APPARATUS AFFECTED: 35BS Automatic Send-Receive Teletypewriter-Set
TP320248 Stunt Box Assembly (AUS) Used on 35G Typing Unit
TP310719 Keypop Set (ATX) Used on 35K Automatic Send-Receive Teletypewriter Base
35N Electrical Service Unit

PART AFFECTED: TP192467 Function Bar (DC3) TP180172 Keypop (W)

REASON FOR REISSUE: To change classification.

Sheet 3, Issue 2

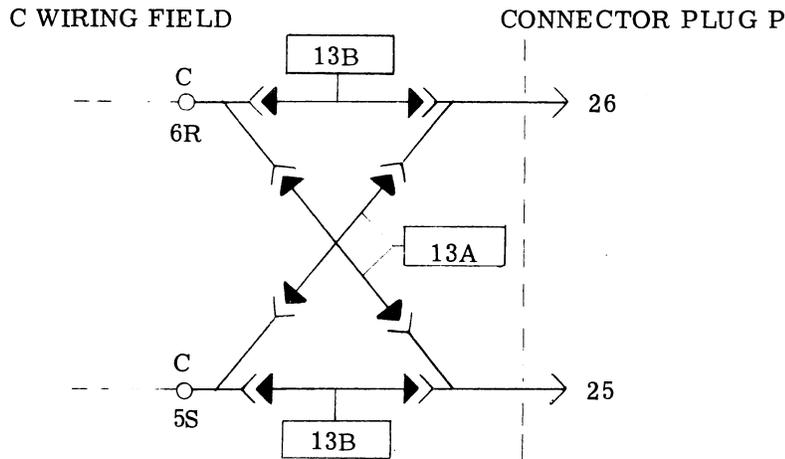
Area E-4

The transmitter distributor clutch magnet circuit between C wiring field and P connector plug is rearranged as shown below:

Attached Sheet 1

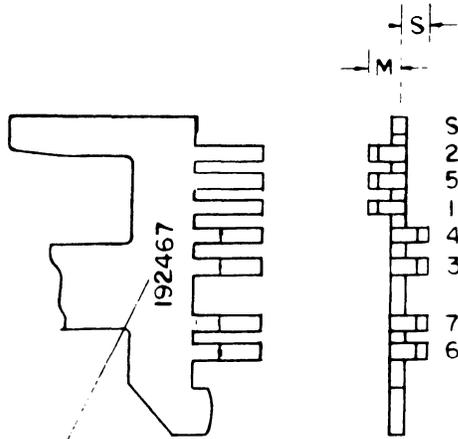
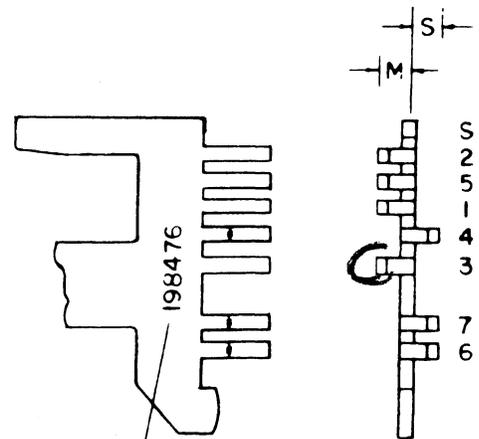
The TP192467 function bar (DC3 - X-OFF) in slot 23 of the TP320248 stunt box assembly is replaced by the TP198476 function bar (DC7 - ETB). See Attachment Sheet 1.

The TP180172 keypop (W) used on the TP310719 keypop set is replaced by the TP185290 keypop (DC7/W) which corresponds with the DC7 (ETB) function of the typing unit. See Attachment Sheet 1
